ADDENDUM NO. 2

SMITHS FALLS HYDROELECTRIC PROJECT

**Stowe Electric Department
 Stowe, Vermont**

**Original Bid Package Issued December 15, 2025
 Addendum No. 2 Issued January 23, 2026**

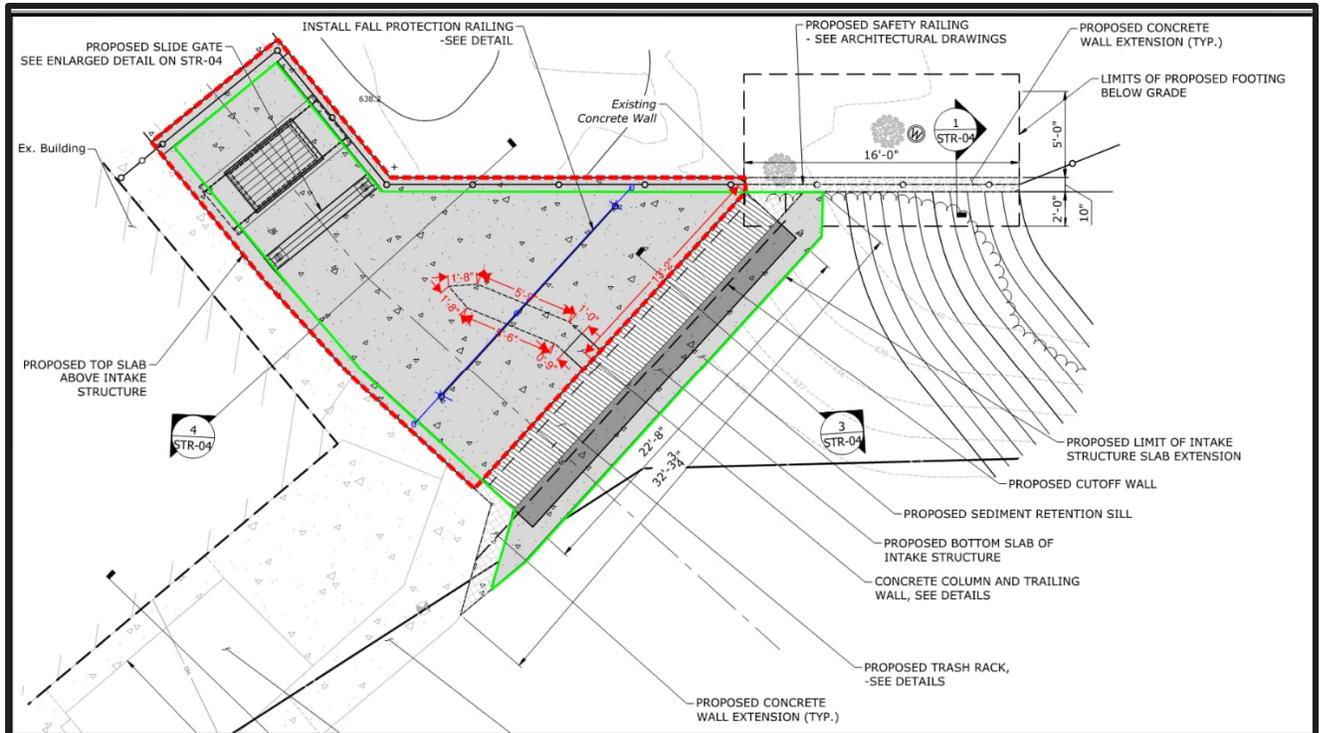
-
- Q10. Please note the proposed intake details as shown on STR-04 and advise on the following:**
- a. Please confirm that the intent is the re-use the existing sluiceway/intake foundation walls (section 4/STR-04), which will be extended as a retaining wall on the north side of the intake (section 1/STR-01) and a single faced wall on the south side.**

- b. Please provide details and dimensions for the single faced wall on the south side of the intake.**
 - c. Section 3 and 4, indicate the construction of a new base slab for the intake, however the dimensions are not provided. Please provide the dimensions or the delineation between new and existing for the new slab.**

- d. The plan view of the intake shows dashed lines which appear to indicate some sort of trailing wall below the proposed top slab, downstream of the new column. Please provide dimensions and reinforcement details for this wall.**

- e. The concrete column is shown in plan on STR-04 and in elevation on STR-05, specifically in the elevation named 'Intake with Trash Rack'. In this elevation, it appears that the column is centered on the 22'-8" trash rack, however in plan view the placement is offset substantially from the racks. Please advise.**

- R10.**
- a. Existing walls will be re-used. A new top and bottom slab will be installed at the proposed intake will be installed as shown on the plans and details. The proposed bottom slab shall have waterstops installed at the face of the existing walls.

- b. The wall should be constructed to join the face of existing concrete mill structure with the inside face of sluiceway wall. Thickness of the wall may vary based on field conditions. Plans are drawn to scale.

- c. See the sketch provided below for the plan area of base slab outlined in green. The plan area outlined in dashed red represents extent of top slab.

- d. The trailing wall shall have vertical reinforcing on each face, #5 @ 12" o.c. and horizontal reinforcing on each face, #5 @ 12" o.c. extending 12" into concrete column. Wall is 18" thick. See sketch for length dimension.

- e. See the sketch provided below for the horizontal placement of pier.
 - f. See the response to Question #5 in Section B for more information.
 - g. See the response to Question #5 in Section B for more information. All pieces shall be stainless steel, and bars shall be welded to the frame.

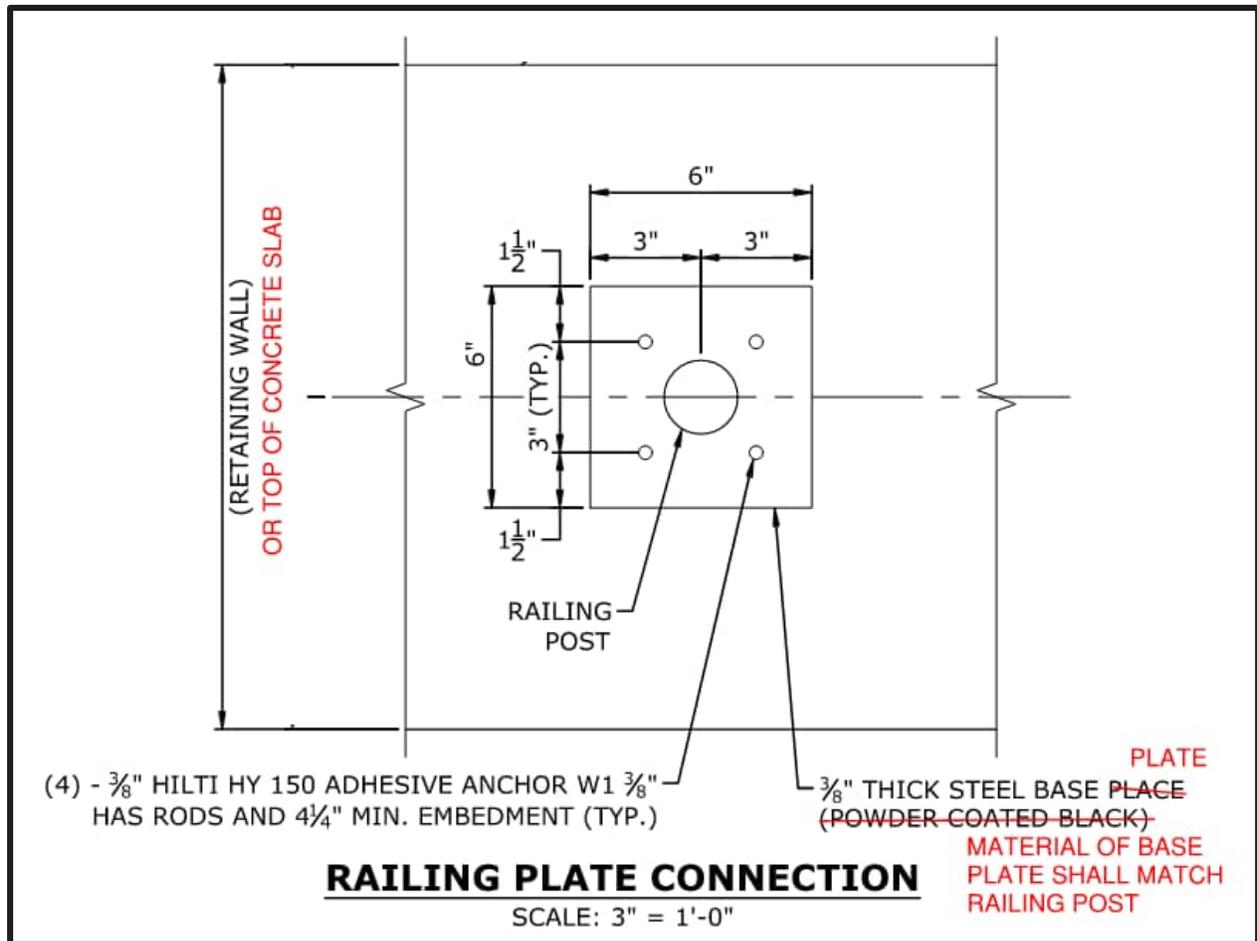
Q11. Safety railings are shown in various plan drawings, on the east and west sides of the mill, placed on the new sluiceway top slab, and note to refer to the Architectural drawings for details. Please provide the following:

- a. Post spacing and connection details to the structure.
- b. Details for the 'lockable gate' as shown in plan on SP-01.
- c. Please confirm that the finish is 'galvanized' and not painted.
- d. It appears that there is a section of railing between the proposed concrete retaining wall and the existing millwright office. Please confirm that this is the intent, provide the dimension of the railing and foundation details.

R11. a. The safety railing shall consist of a 1-1/2" Dia. Galvanized Rail that is 42" high with 1" Dia. Balusters spaced 4-1/2" o.c. The posts shall be spaced a maximum of 6 feet o.c. See the sketch provided below for railing plate connection detail.

b. It is anticipated that the manufacturer of the safety railing will have lockable gate options. For pricing purposes, please carry a \$1,000 allowance to cover the cost of the gate in the Lump Sum bid price. The Contractor shall be required to provide shop drawings for review and approval.

c. Yes, the safety railing shall be galvanized steel.

d. Yes, the safety rail between the end of the retaining wall and existing Millwrights Office building is required. The on-grade section of safety railing shall be founded using 12" concrete Sonutubes that are a minimum 4 feet deep, and the railing post shall be embedded a minimum 12" into the concrete. The plans that show the safety railings are drawn to scale.

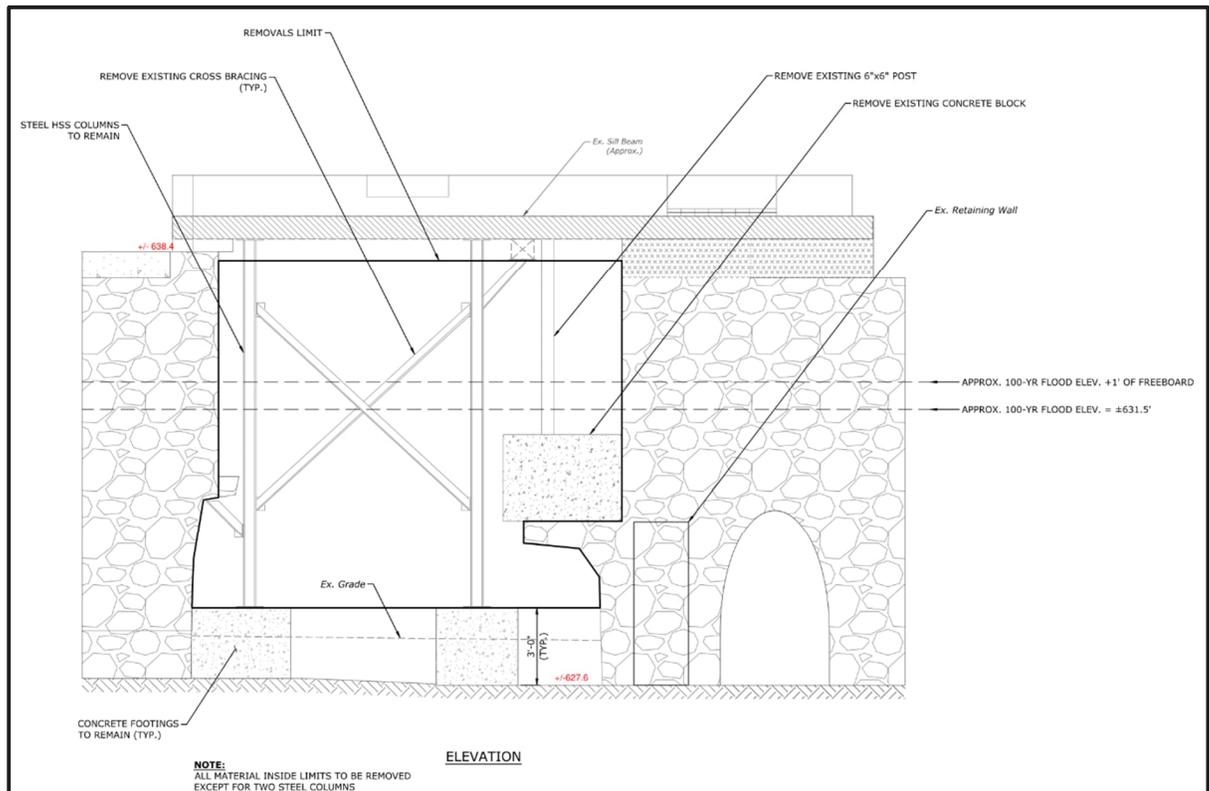
- Q30.** There are no elevations on sheet STR-10. The drawing just states, "See grading and Utilities plan". Please provide some approximate elevations on the mill building to provide the relative heights as compared to the water elevations and the elevations of the new sluiceway.

- R30. See sketch below and sheet STR-01 for spot elevations.

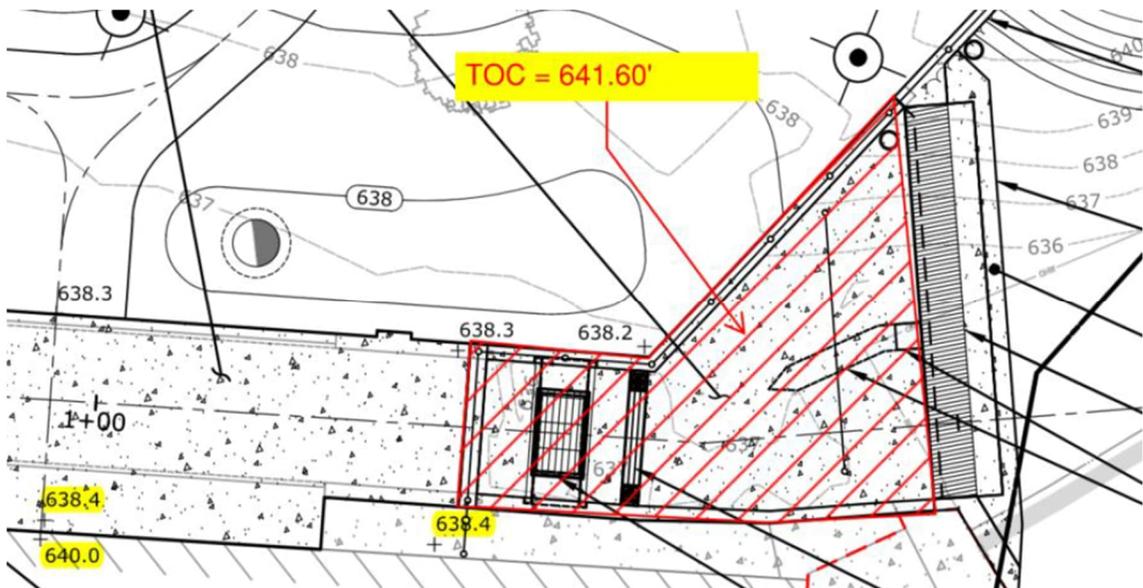
g. Detail 2/A2,1 notes 2x10 rafters and a 2x? rafter tie. Please advise on the following:

i. Is the rafter spacing intended to match that of the wall (16” O. C.)?

ii. Please provide the size of the rafter tie.

g. The rafters shall be spaced 16" o.c. to match the wall stud spacing. Rafter ties shall be 2x8. A connection plate is not required, unless required by Vermont Building Code or local ordinances. Manufactured wood trusses would be an acceptable alternative to rafters, contractor shall provide shop drawings for review and approval if proposed.
